Official Notification - Federal Boat Safety Act Towershaft Lever Stop 1995 40/50 HP Models

1995 40/50 HP Models

S/N 0E093700 TO S/N 0E119819

- 1 - Towershaft Lever
- 2 - Towershaft Link Assembly

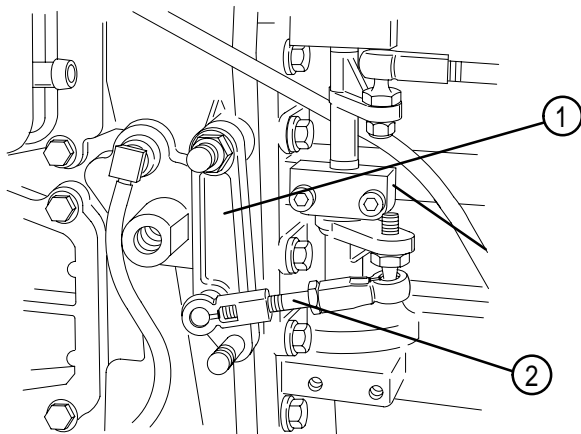
A potential problem was found by Engineering while conducting performance tests. One of the ends of the towershaft lever link between the towershaft lever and towershaft could disengage during a hard acceleration maneuver causing loss of throttle control. As a result, we are initiating a recall pursuant to the Federal Boat Safety Act.

A towershaft lever stop kit was designed to eliminate this potential problem. The part number for this kit is 830121A1.
